STRUCTURES DESIGN BULLETIN 13-08

DATE: June 11, 2013

SUBJECT: Top Slab Tendons Across Mid Span Closure Pours in Balanced Cantilever Segmental Bridges

Figure 4.5.5-1 Top Slab Tendon Layout versus Web Spacing At Mid Span Closure Pours

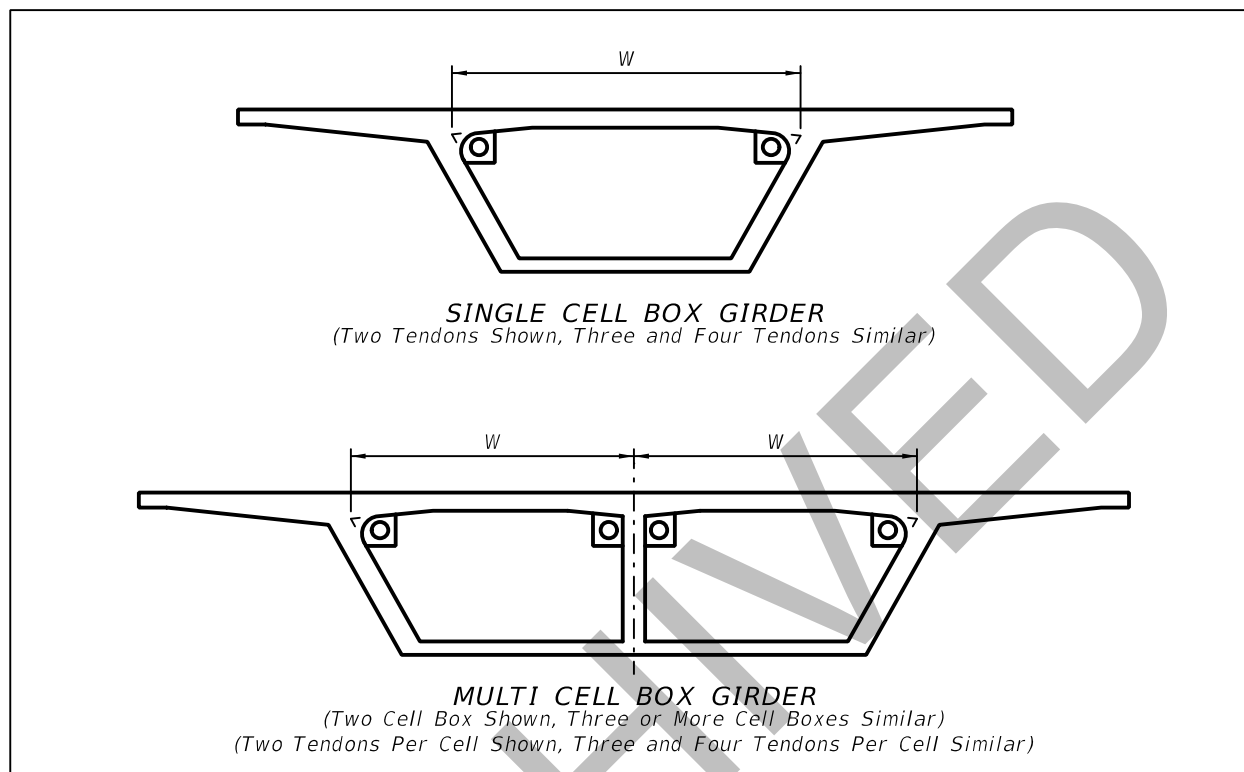
2. Add the following new section, table, figure and commentary to *Structures Design Guidelines*, Section 4.5.5 at the end of the section:

K. Provide top slab continuity tendons across mid span closure pours in balanced cantilever bridges as follows.

1. For boxes with wing lengths less than or equal to $0.6 \times W$ (See Figure 4.5.5-1), provide top slab continuity tendons across mid span closure pours as shown in Table 4.5.5-4.

2. For boxes with wing lengths greater than $0.6 \times W$ (See Figure 4.5.5-1), use the following methodology to determine top slab continuity tendon configurations:

- a. Determine lateral distribution of tendon force across the top slab using *LRFD* [C4.6.2.6.2] (the *LRFD* 30-degree model).
 - b. Locate top slab tendon anchors sufficient distances back from the closure pour to ensure full distribution of tendon forces across the closure pour and so that the tendons overlap a minimum of one pair of cantilever tendons. Do not anchor top slab tendons in the segments adjacent to the closure pour.

- c. Provide a minimum of 75 psi compression across the top slab assuming a uniform stress of P/A on the top slab area only (See Figure 4.5.5-1). Neglect the effects of the bottom slab continuity post-tensioning for this calculation.

- d. Locate top slab tendon anchors adjacent to the webs as shown in Figure 4.5.5-1. Provide additional tendons evenly spaced across each cell and within the wings as required to provide the required uniform minimum compression.

Commentary: This is a minimum requirement and is not to be added to those required by the longitudinal analysis, i.e. if the number and size of top slab tendons across closure pours required by the longitudinal analysis exceeds these minimums, no additional tendons are required.
